**REQUEST FOR ADDITIONAL INFORMATION
ON AIRCRAFT HAZARDS – PARTIAL RESPONSE
DOCKET NO. 72-22 / TAC NO. L22462
PRIVATE FUEL STORAGE FACILITY
PRIVATE FUEL STORAGE L.L.C.**

**RESPONSE TO MARCH 9, 2001 NRC REQUEST FOR ADDITIONAL INFORMATION
REGARDING AIRCRAFT AND CRUISE MISSILE HAZARDS AT THE
PRIVATE FUEL STORAGE FACILITY**

Skull Valley Weather (Fig. 9-9)

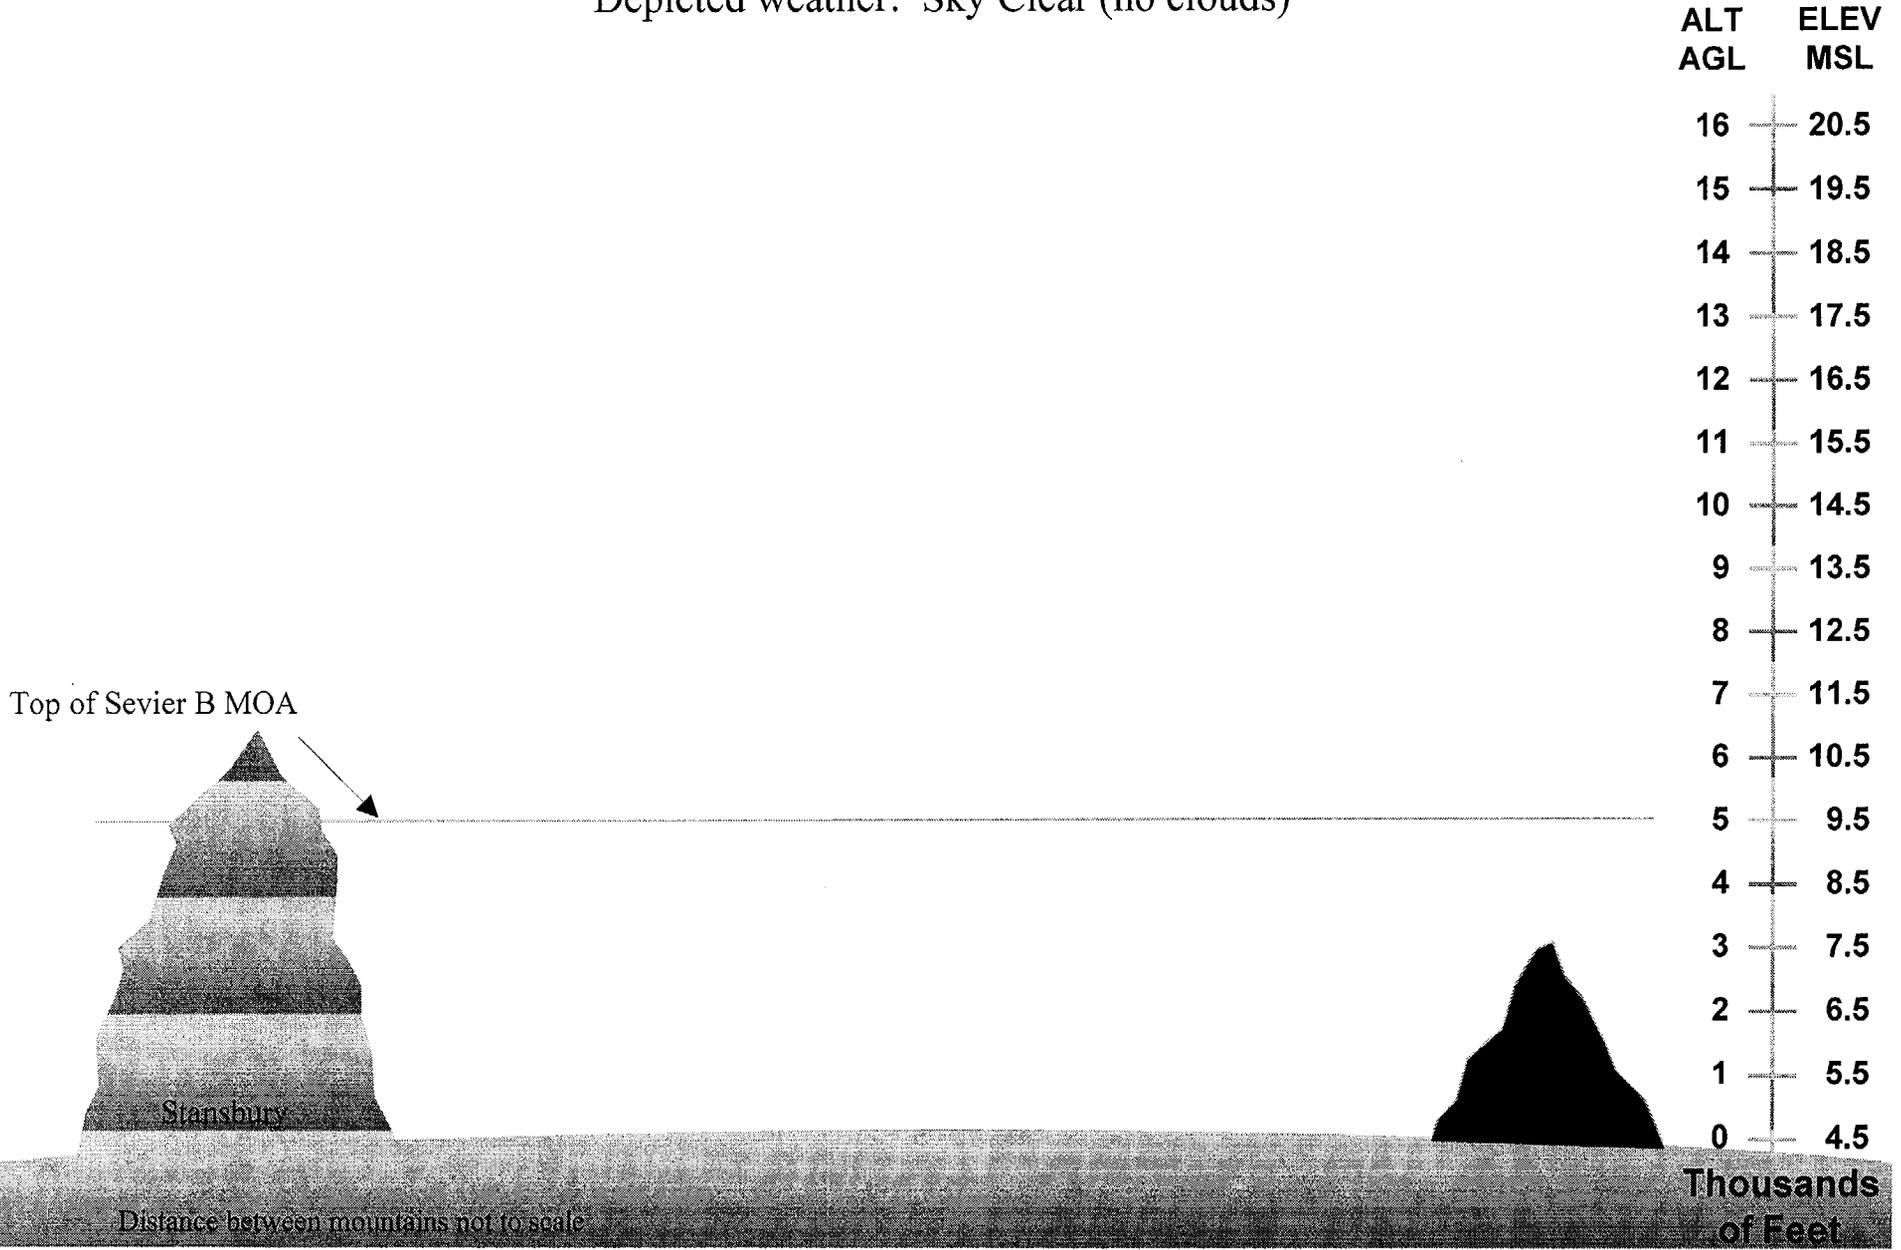
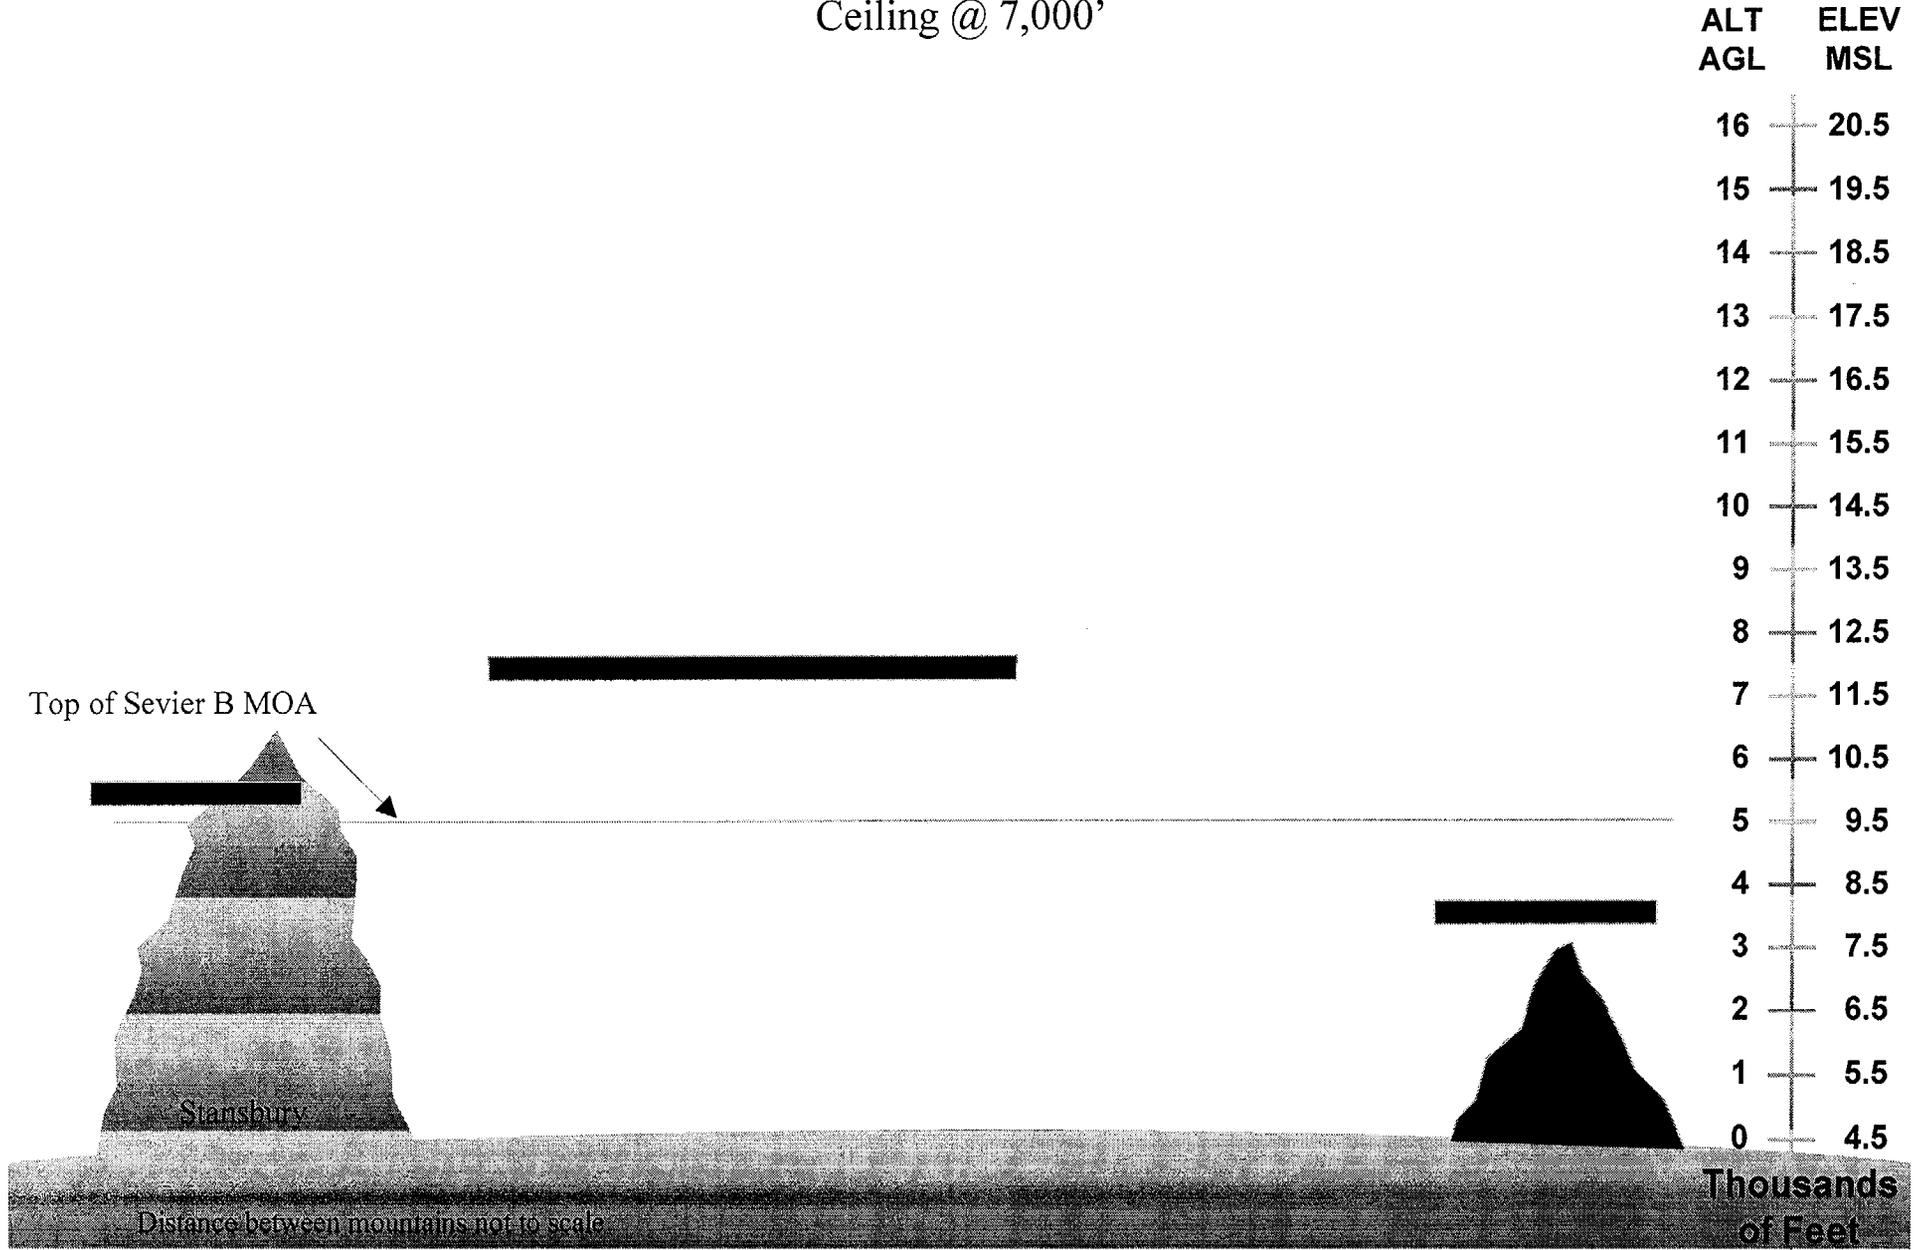
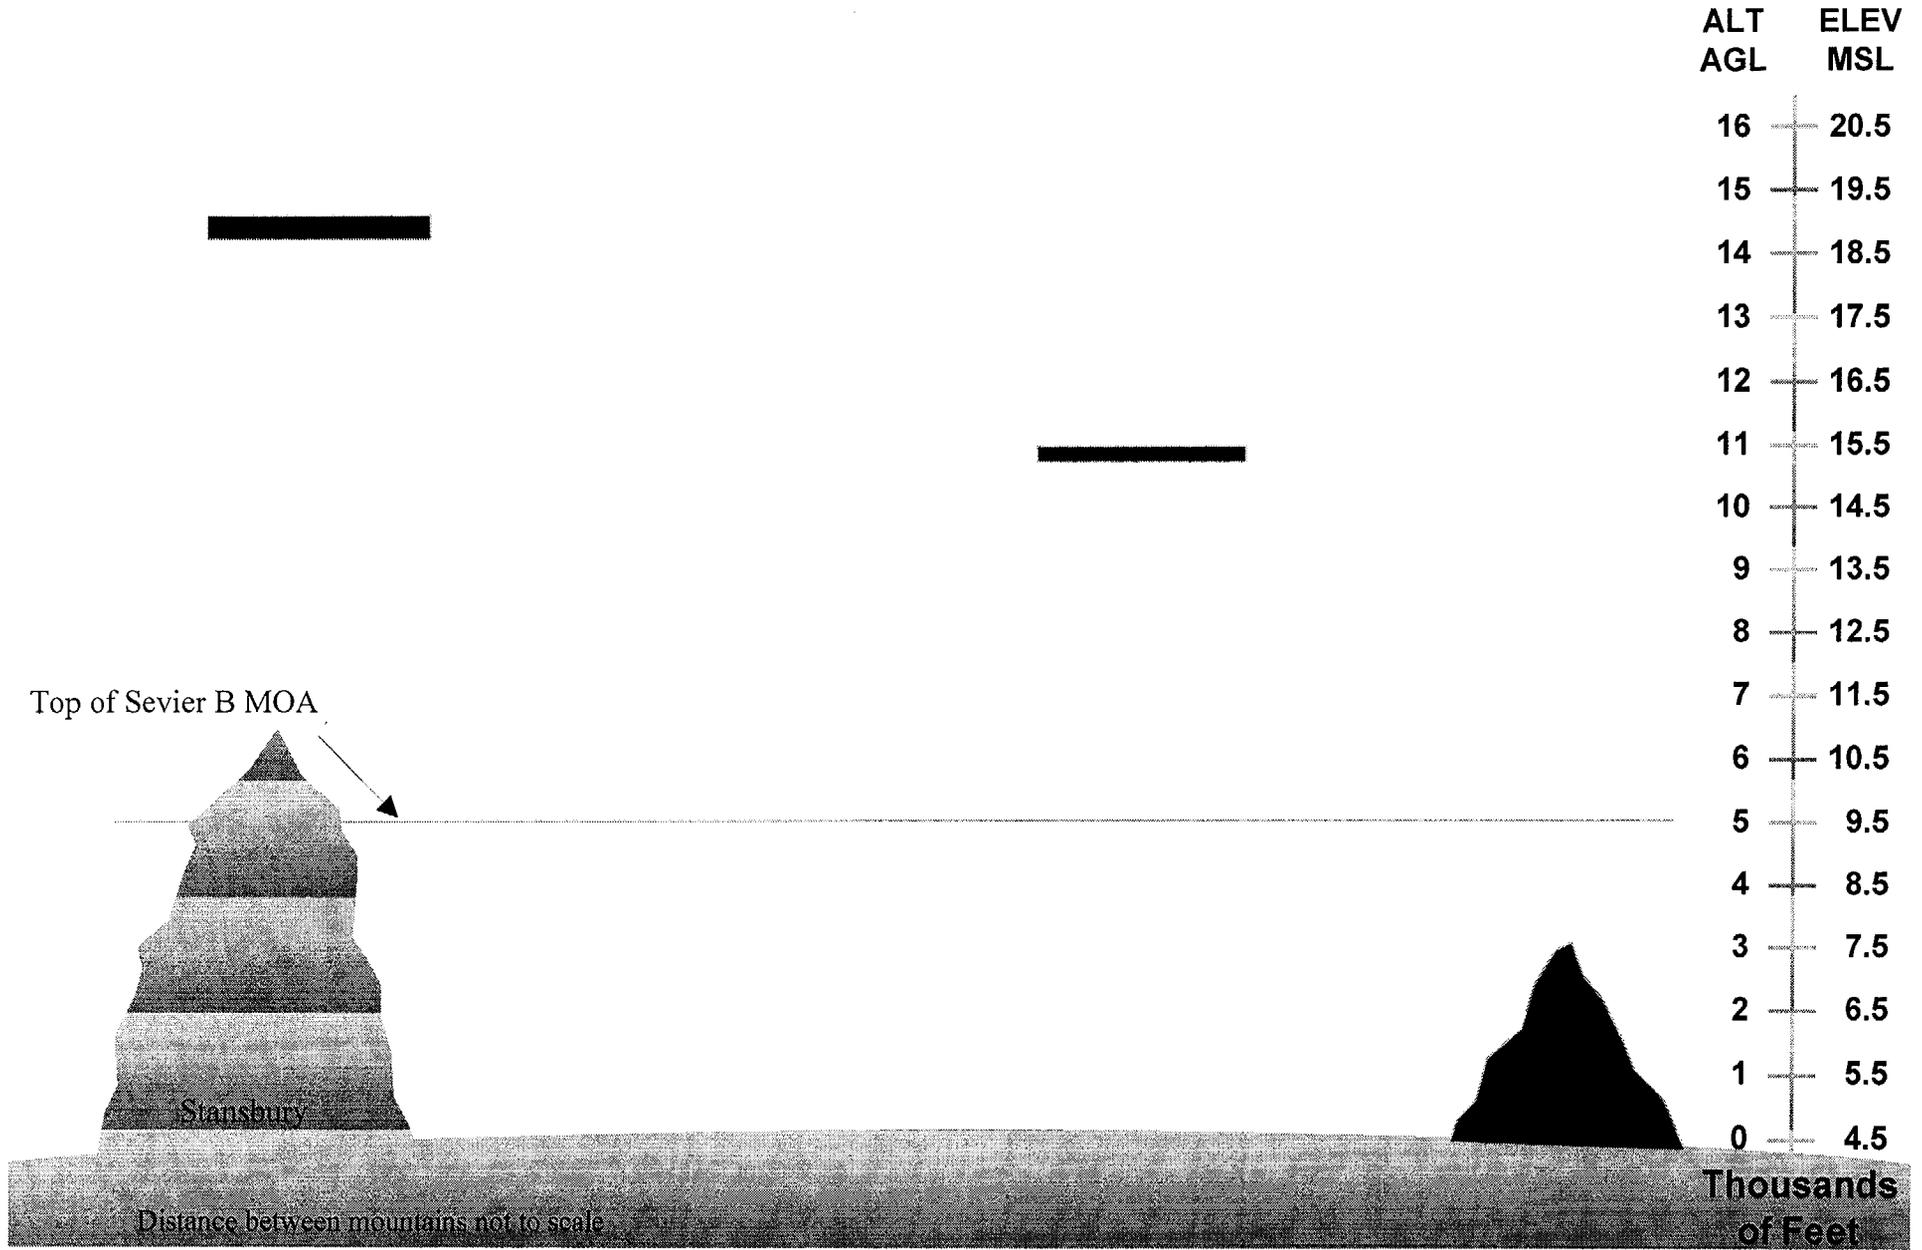
Figures 9-9 through 9-12 show examples of the ceiling and visibility which correspond to the Sevier B MOA. As can be seen from the AWS data, this is the prevailing ceiling and visibility condition 91.5% of the time. In essence, pilots should be able to maintain VFR in the Sevier B MOA the vast majority of the time.
